# SERVICE BULLETIN

Service Bulletin No.: DA20-27-02, Rev. 0

Title: Trim Display Modification.

FIGURE 1.

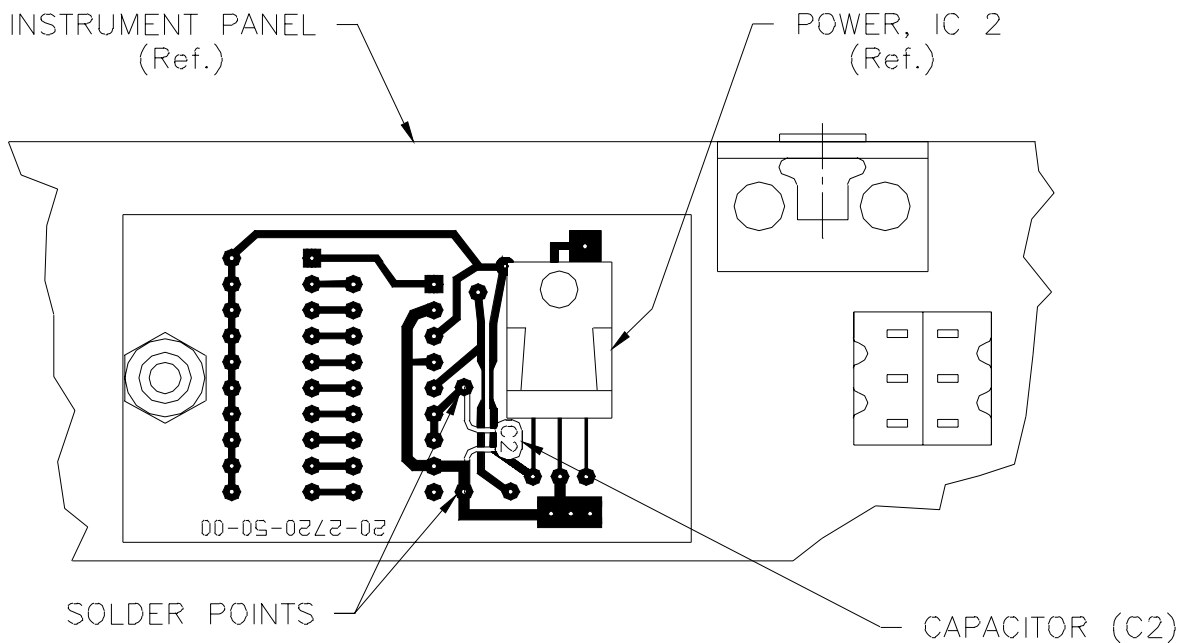
3. General: The existing Trim Indicator flickers when the VHF Transceivers are transmitting. This usually occurs in the higher end of the frequency range. The installation of this Service Bulletin will eliminate this occurrence.

11.1.3 Solder the Capacitor (C2) to the back of Trim Display as shown in Figure 1. It is important that the leads of the Capacitor are kept as short as possible. Make sure that the solder used is a resin core type.
